TO: Mayor Kaysen and City Council  
FROM: Development Department (Mike Tylka)  
SUBJECT: Holmes Corner Preliminary Plat - Updated Map Submission & Conditions  
Clarification (UDC-15-00816)  
DATE: February 11, 2016

## DRAFT FINAL PLAT OF HOLMES CORNER

## PRELIMINARY PLAT OF HOLMES CORNER

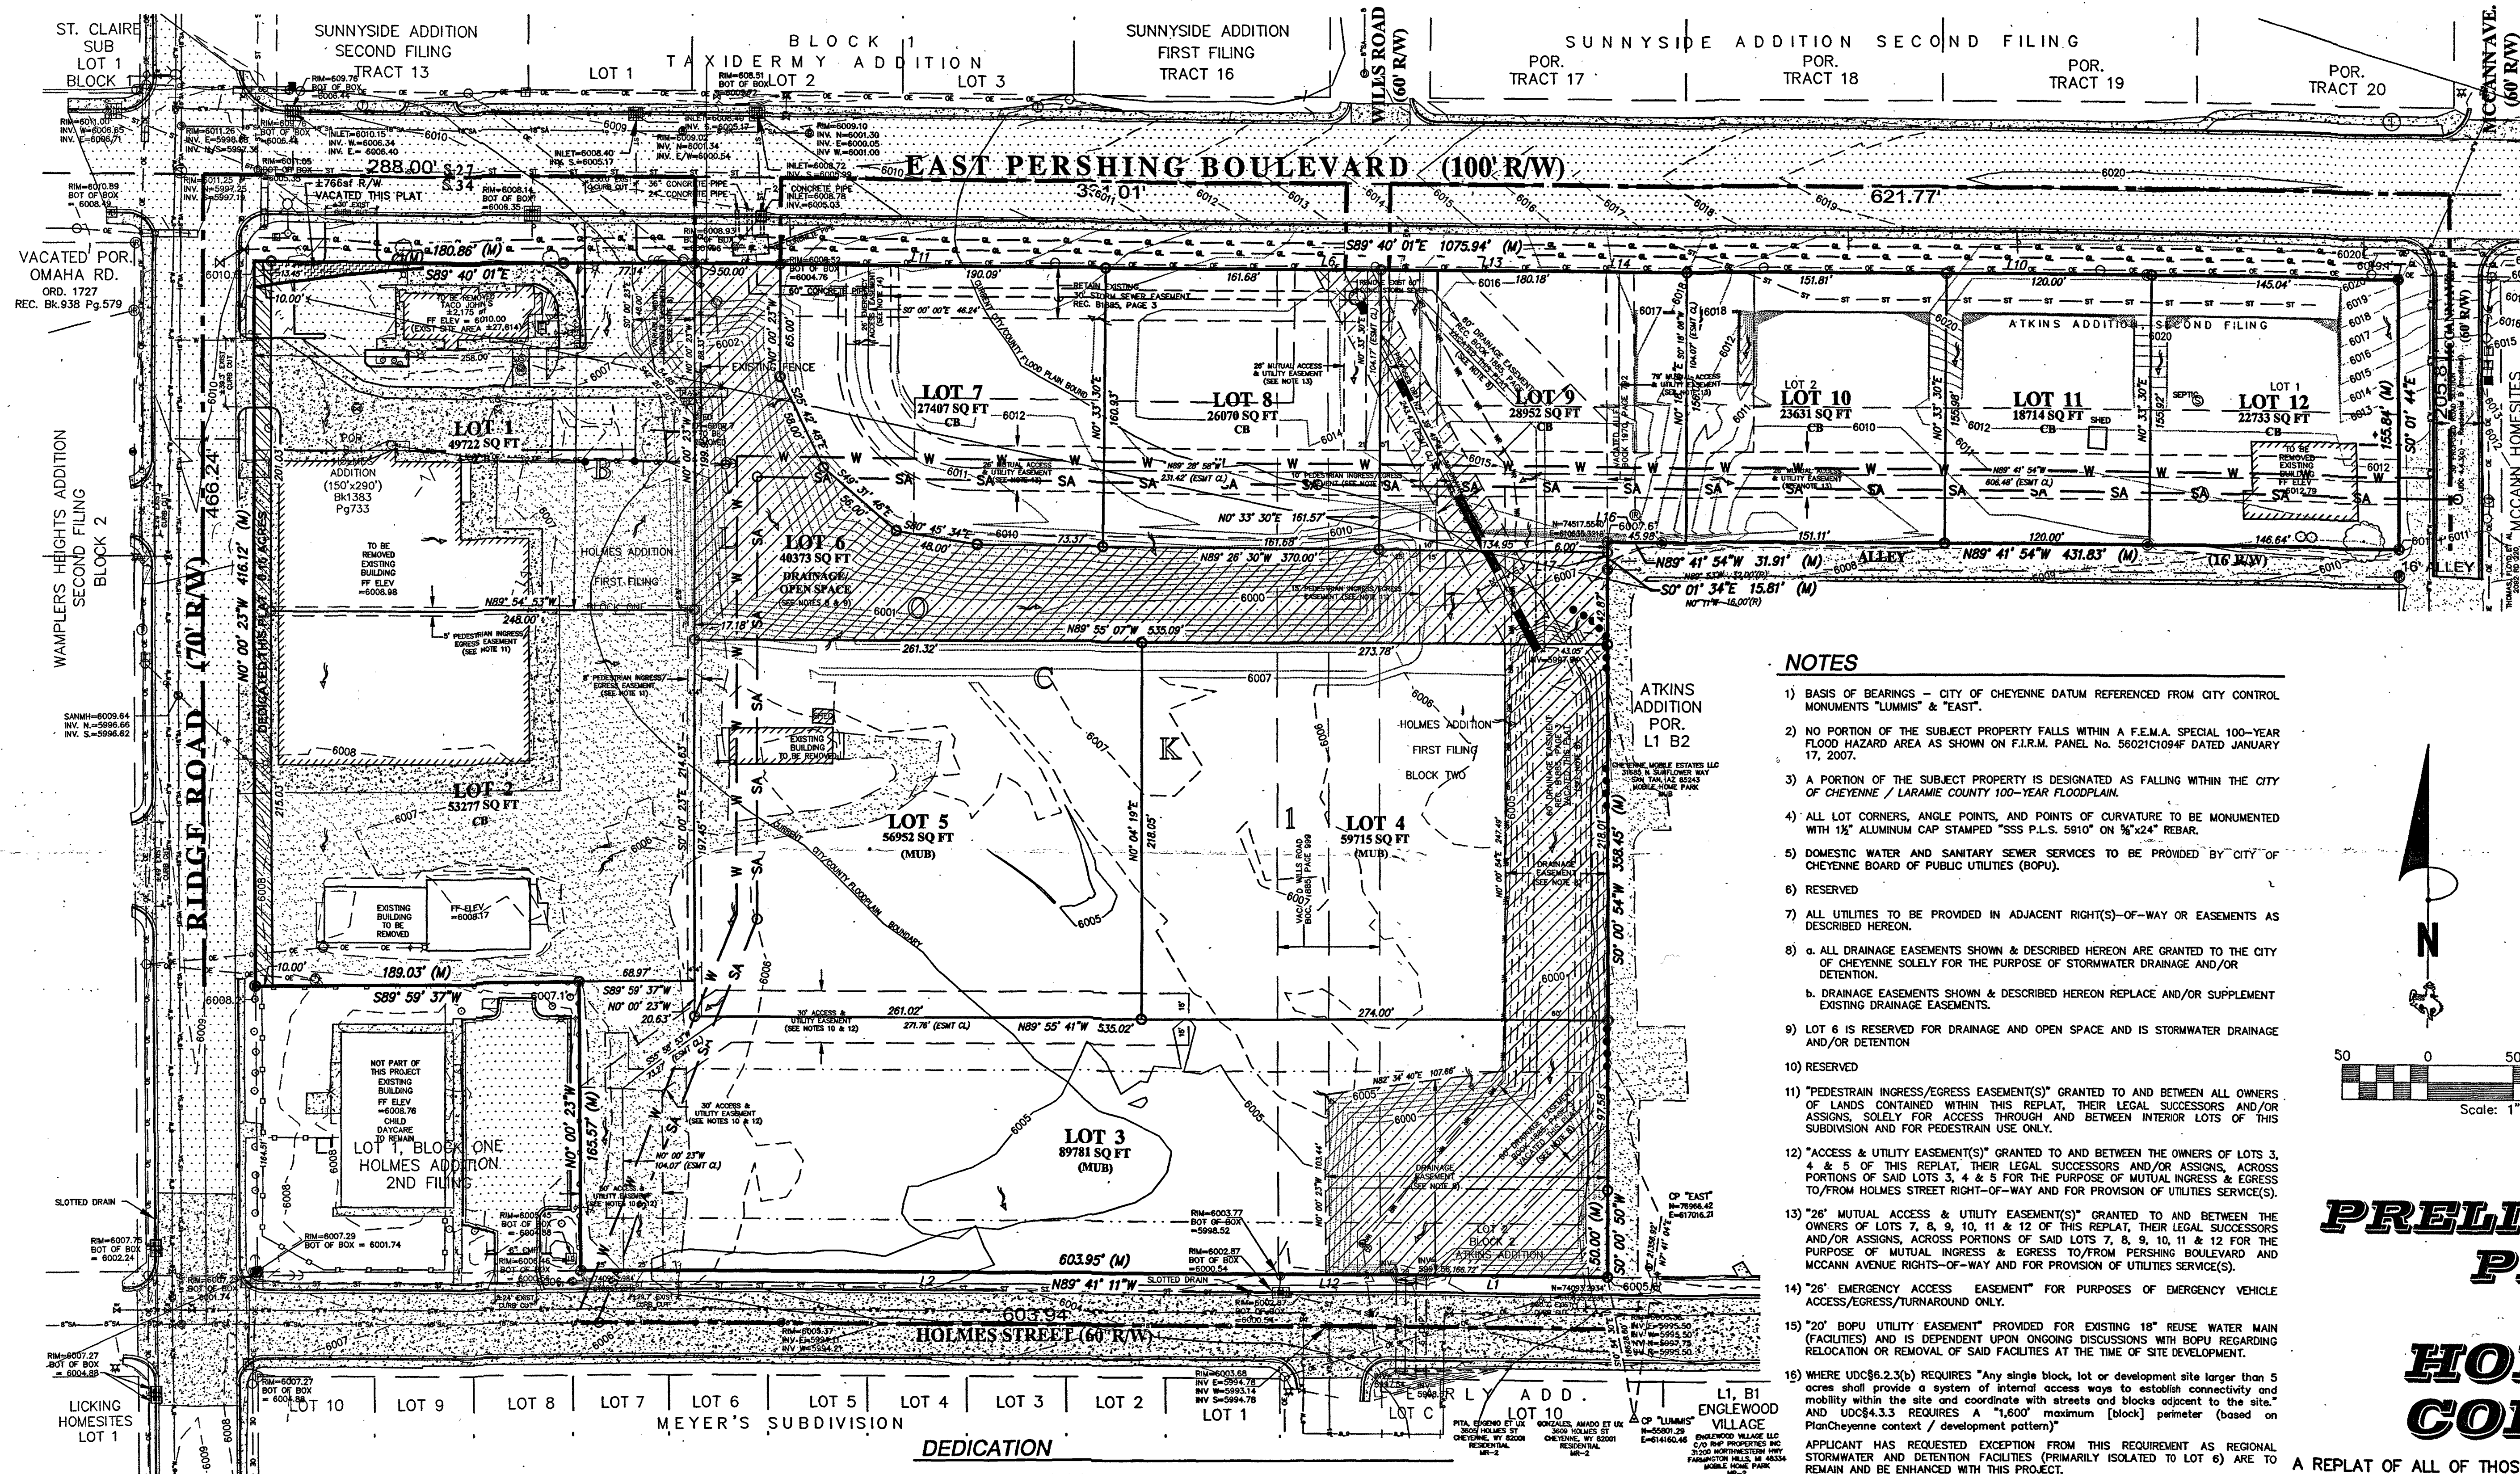
- 1.) ***That Lots 3-5 be identified for future zoning of NR-3 Neighborhood Residential – High Density or CB Community Business.***
- 2.) ***That the Board of Public Utilities concerns are met in regards to the reuse water line running through the property.***

In addition, at the meeting on the 4<sup>th</sup> the agent stated that they would address Staff concerns regarding street network connectivity and block size standards, as of the date of this memo the agent has not, and therefore Staff is recommending a third condition as follows:

- 3.) ***That the applicant addresses street network connectivity and block size standards as identified in the Unified Development Code.***

- 14) "26" EMERGENCY ACCESS EASEMENT" FOR PURPOSES OF EMERGENCY VEHICLE ACCESS/EGRESS/TURNAROUND ONLY.
- 15) "20" BOPU UTILITY EASEMENT" PROVIDED FOR EXISTING 18" REUSE WATER MAIN (FACILITIES) AND IS DEPENDENT UPON ONGOING DISCUSSIONS WITH BOPU REGARDING RELOCATION OR REMOVAL OF SAID FACILITIES AT THE TIME OF SITE DEVELOPMENT.

- 16) WHERE UDC§6.2.3(b) REQUIRES "Any single block, lot or development site larger than 5 acres shall provide a system of internal access ways to establish connectivity and mobility within the site and coordinate with streets and blocks adjacent to the site." AND UDC§4.3.3 REQUIRES A "1,600' maximum [block] perimeter (based on PlanCheyenne context / development pattern)"  
APPLICANT HAS REQUESTED EXCEPTION FROM THIS REQUIREMENT AS REGIONAL STORMWATER AND DETENTION FACILITIES (PRIMARILY ISOLATED TO LOT 6) ARE TO REMAIN AND BE ENHANCED WITH THIS PROJECT.
